Consensus proposal for resolving comment #188

The concern described in the comment

Figure 178B-10a—Training control state diagram, part 1

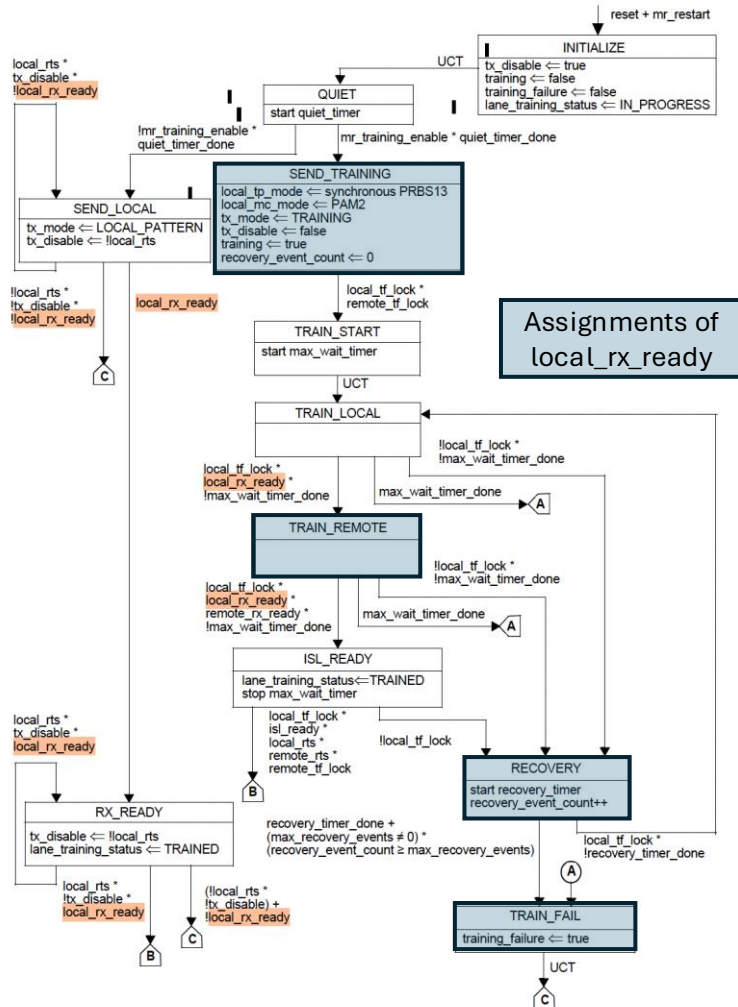
Debouncing local_rx_ready

Rename the internal variable to rx_ok in the highlighted places

(Many text changes in the state diagram, but no change in state diagram behavior)

In Figure 178B-10, change all instances of **local_rx_ready** to **rx_ok**, and add the assignments of local_rx_ready: set to false in SEND_TRAINING, RECOVERY, and TRAIN_FAIL; set to true in TRAIN_REMOTE. Add a new MDIO mapping for rx_ok.

Figure 178B–10a—Training control state diagram, part 1

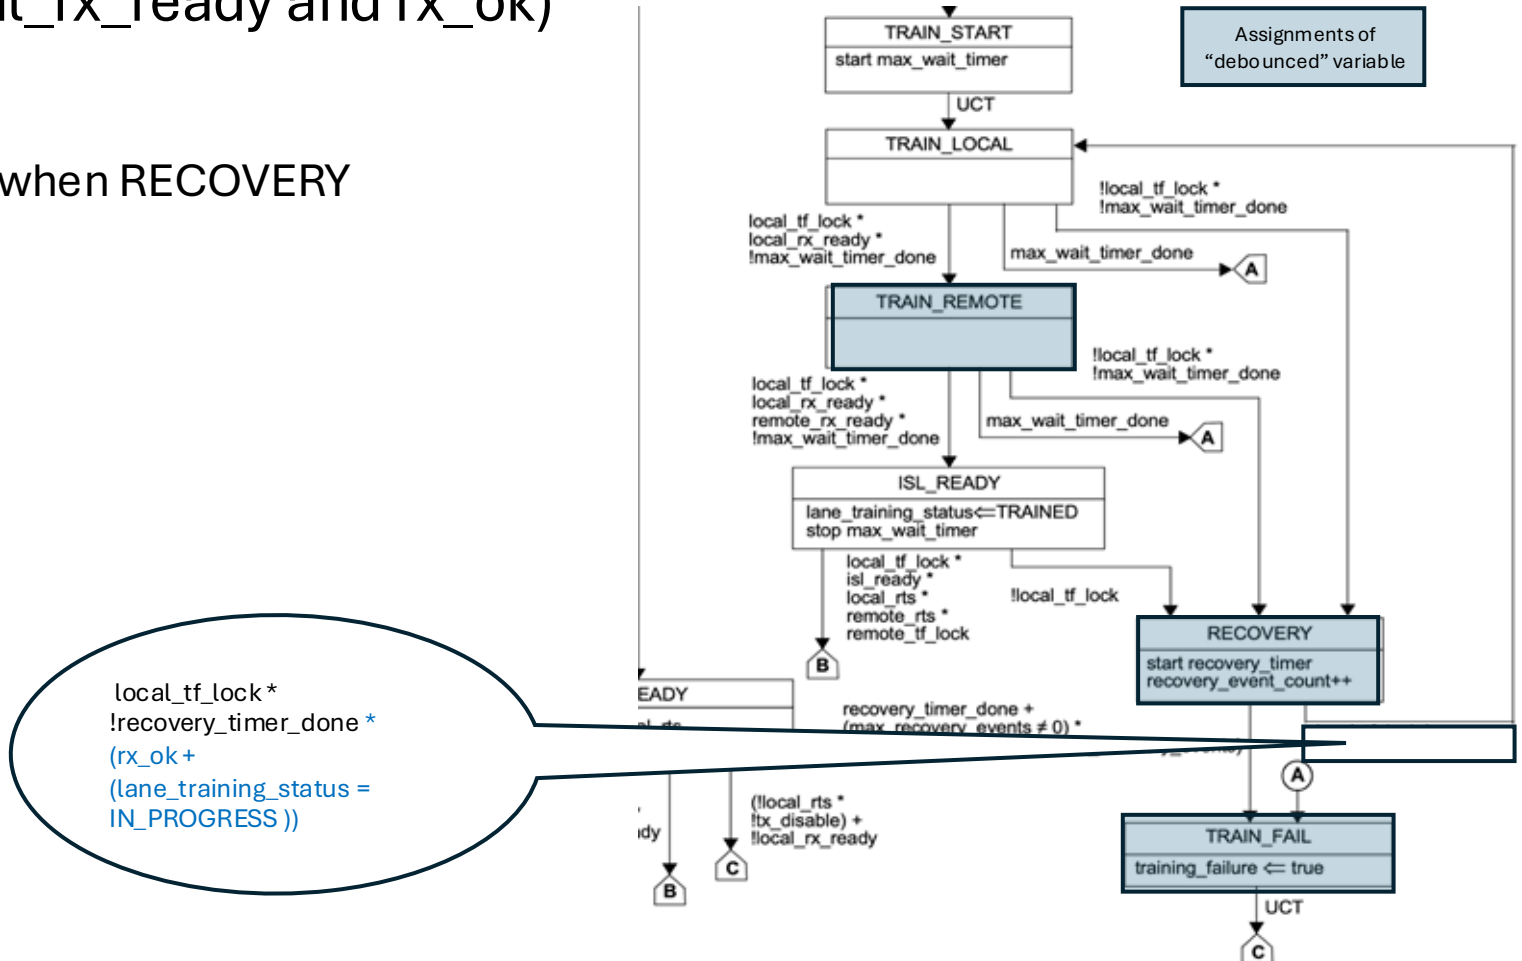
(contingent on separating local_rx_ready and rx_ok)

Prevent a potential deadlock situation (when RECOVERY is entered from ISL_READY)
